Project Name: York Region Admin., Package D Renovation

CONSULTANTS RFI NO: TC24-114-23-X

REFERENCE: [Ground, 2nd & 3rd Floor Chilled Water Main](#)

Ground, 2nd & 3rd floor chilled water main

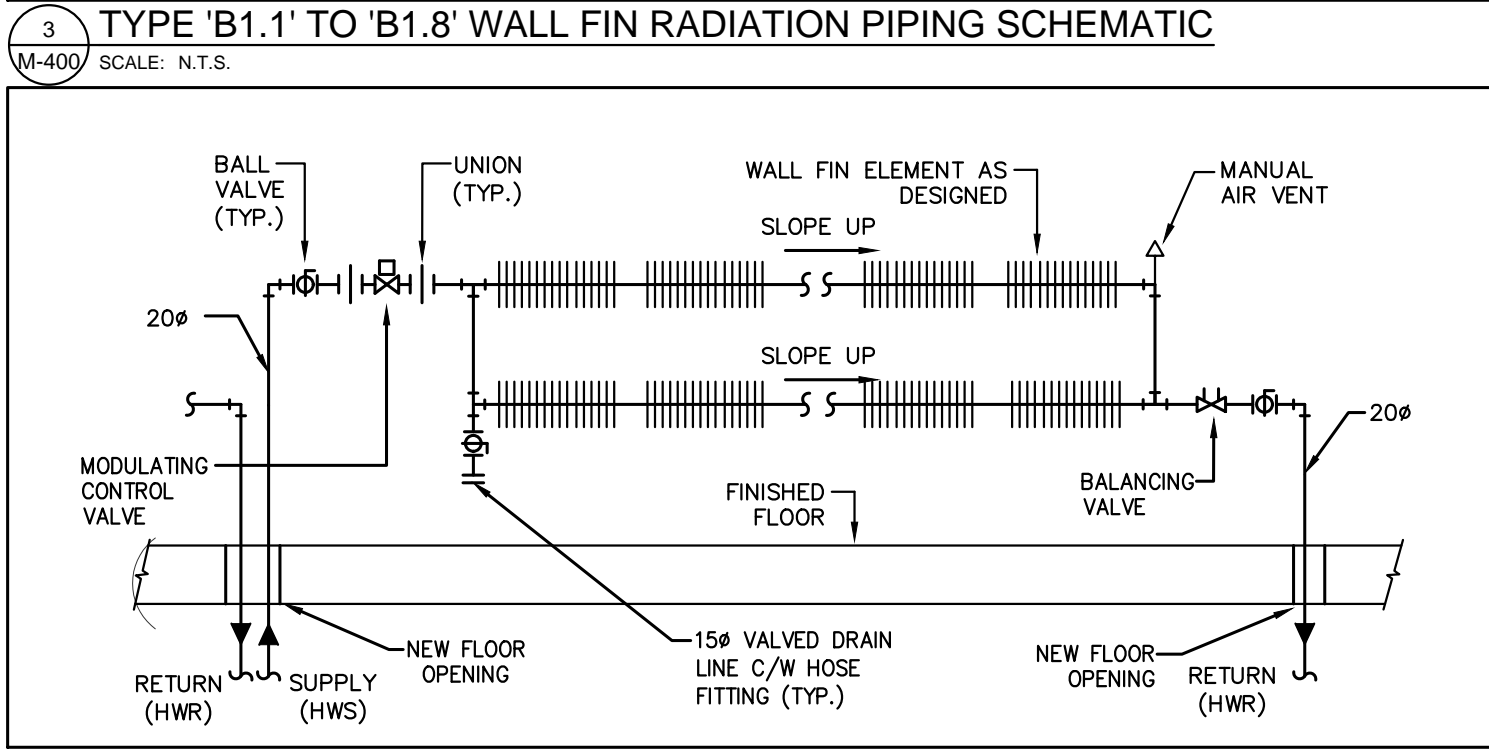
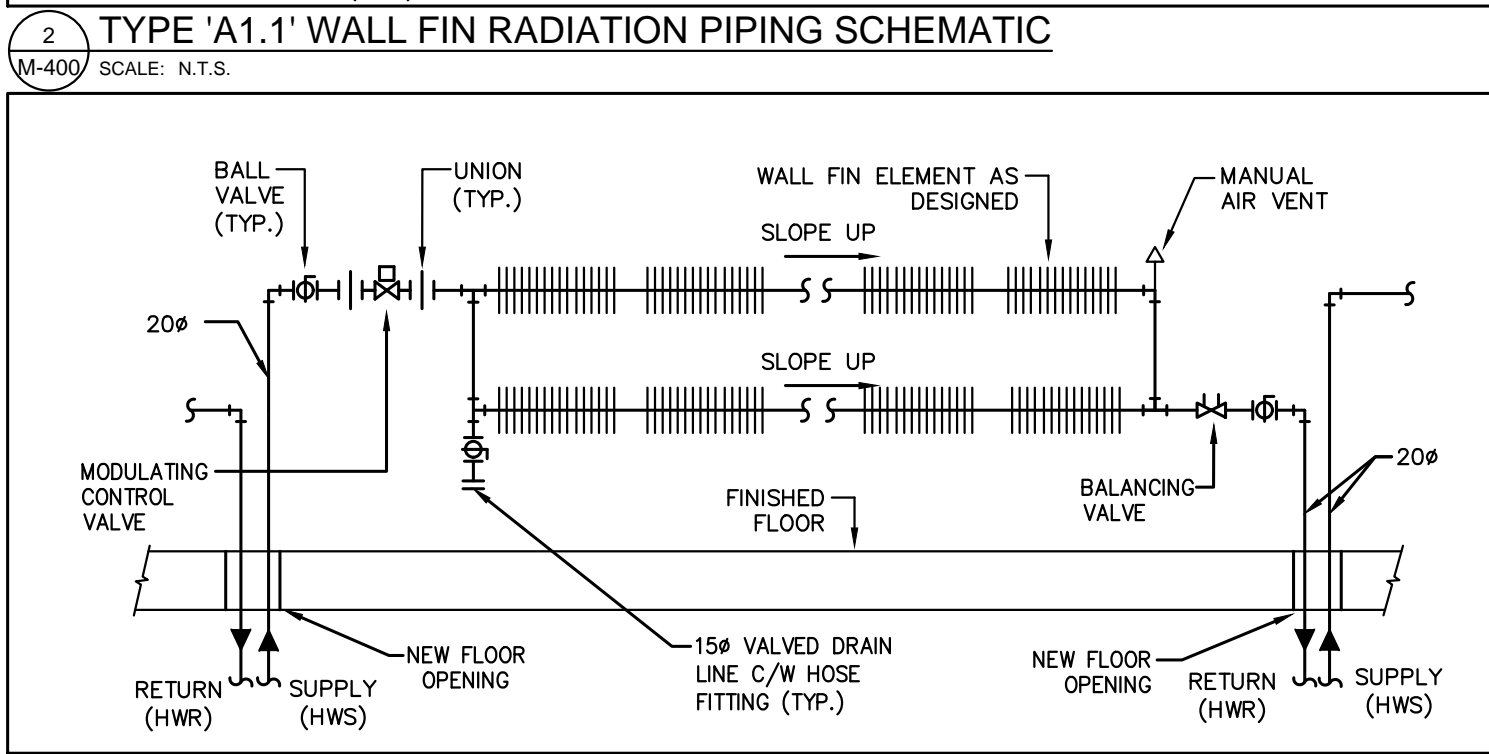
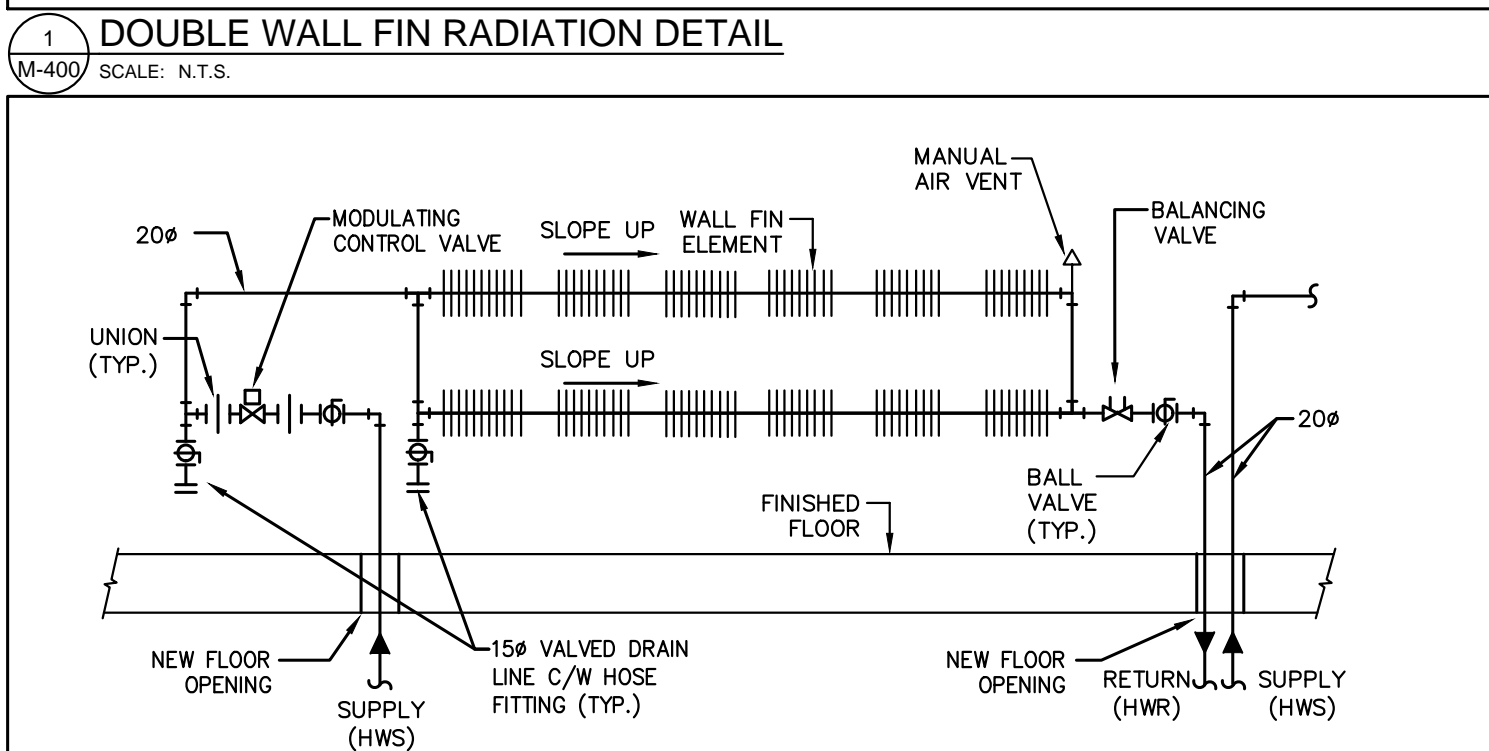
Ground floor chilled water supply main riser to P1:

Location is different from mechanical to architectural. Both suggested locations are above structure concrete caps which we're told can not be cored through. Please advise to where a new location is for the chilled line to penetrate the floor and for us to tie into the appropriate services in P1 level. The suggested location to where we are supposed to tie into the chilled mains is above a separation wall between the staff washrooms and the staff lunch room which is dry walled ceiling. Space is limited in ceiling space due to existing services as well. (Duct work, etc.)

2nd floor:

The same issue looks to be occurring. The location where it goes through the floor is near a column. Below on the ground floor it's in the old cafeteria which is blocked in and tiled. Its not possible see the column on the ground floor to confirm concrete cap underneath. Grid line #14

3rd floor:

On the drawing it shows us running our mains near the column. The current services in the ceiling space have congested that entire area. Please advise on how should we proceed with the location of the new chilled water mains to ensure we are above ceiling height, and don't have to many elevation changes to cause air lock and flow restrictions in the piping system?

1. Ground Floor: Please send us a sketch showing multiple proposed locations for the chilled water riser so that the Furniture Team, Structural, Architect can review and comment.
2. 2nd Floor: Please send us a sketch showing multiple proposed locations for the chilled water riser so that the Furniture Team, Structural, Architect can review and comment.
2. 3rd Floor: Please send us a sketch showing alternate location of the chilled water main routing for our review.

Please refer to attached drawings for alternate chilled water riser locations. Please confirm which location is suitable for architect's and structural consultant's review and approval.
